From: Karen Pratt [REDACTED]
Sent: Wednesday, 10 May 2017 3:10 p.m.
To: TTRLApplication; Christina Smits
Subject: DMC request minute 41, not met
Attachments: image004.emz; image019.emz; image026.emz

Could I please alert the DMC to the fact that their request for information (Minute number 41) for acoustic information has not been met. I have a number of points, fully supported, to evidence why.

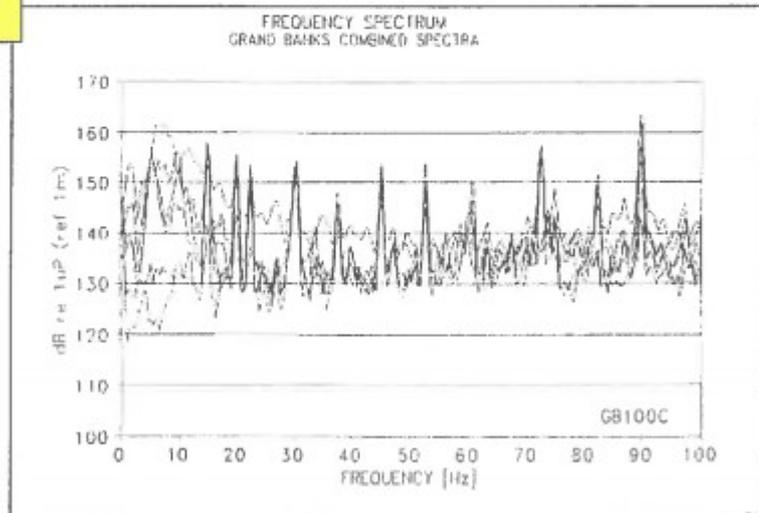
I had to look up details for the two ships – and have found them to be significantly smaller than the TTR vessels. The Louis G Murray is 77m and the Grand Banks is less than 138metres. The Coral Sea 122m in length. So **the relevance is conditional on understanding they are very much smaller than TTR operations – the IMV is 345metres in length.**
